TECHNICAL BULLETIN
Q384 UPS3114-2bNAS1
23 MAY 2014

Update Prior to Sale: Trailer Harness Central Junction Box Connector Pin Locations

LR4 (LA)
Model Year: 2014
VIN: EA699718-EA713882

E165757

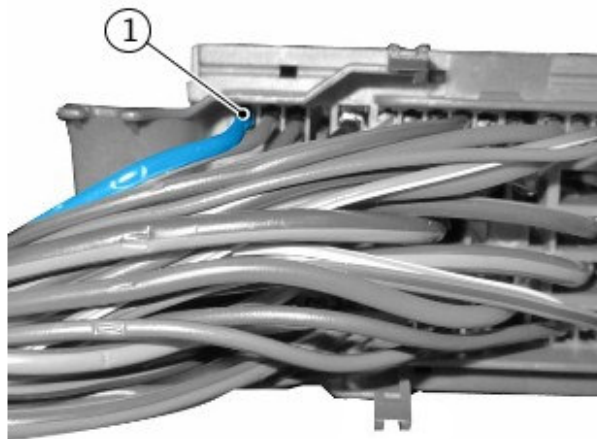
Situation: An issue has been identified on a limited number of 2014 model year LR4 (L319) vehicles within the listed VIN range where the Central Junction Box (CJB) connector has incorrect pin assignments. The CJB connector has pin location '1' wired in error where pin location '44' should be wired. If a trailer wiring harness is installed, the trailer's side and outer marker lamps do not illuminate.

7. Using the release tool 418-593 from the Terminal Repair Kit, remove the wire and terminal from cavity (1) of the connector.

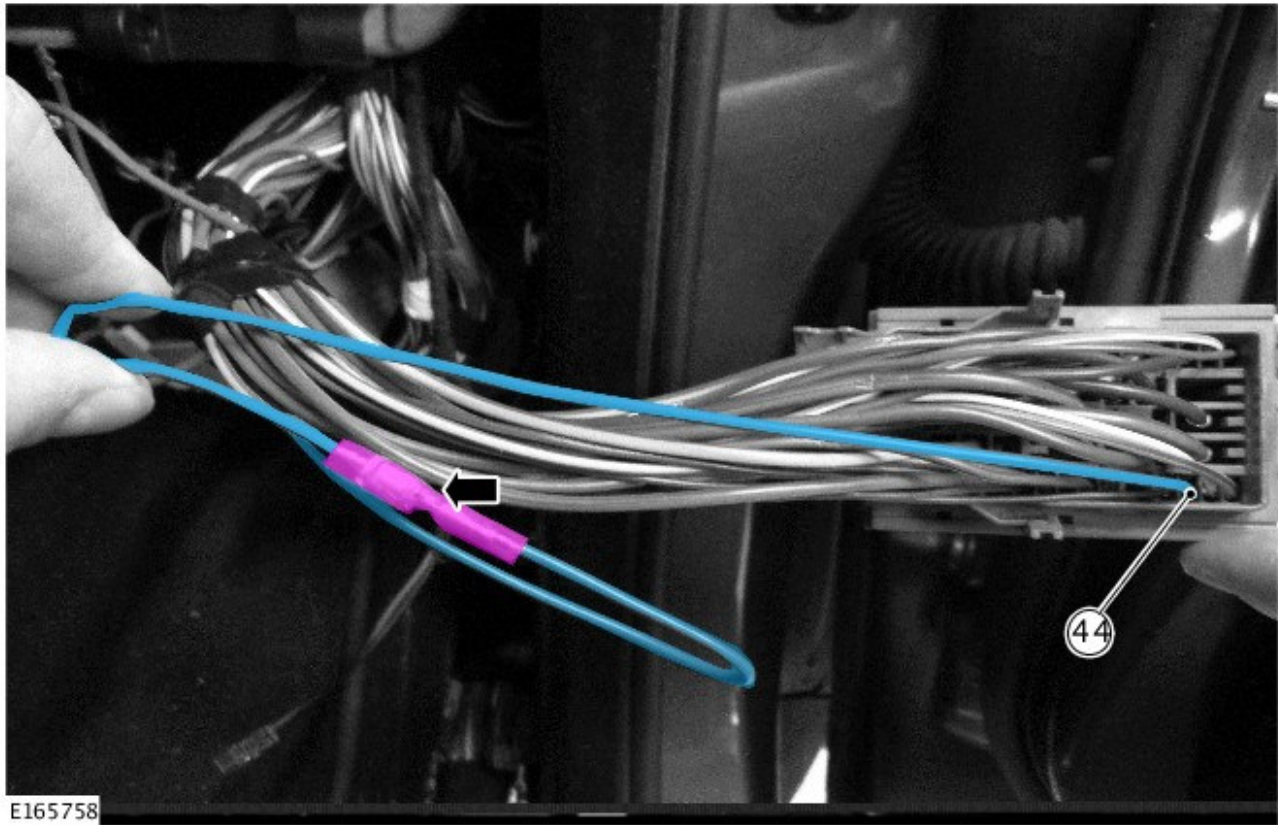
8. Remove the terminal from the end of the wire and extend the wiring as shown using crimp connector splice 418-108 from the Terminal Repair Kit and the supplied electrical tail terminal.

- Use the full length of the electrical tail terminal and loop around.
- Install the terminal into the vacant cavity (**44**) of the connector.
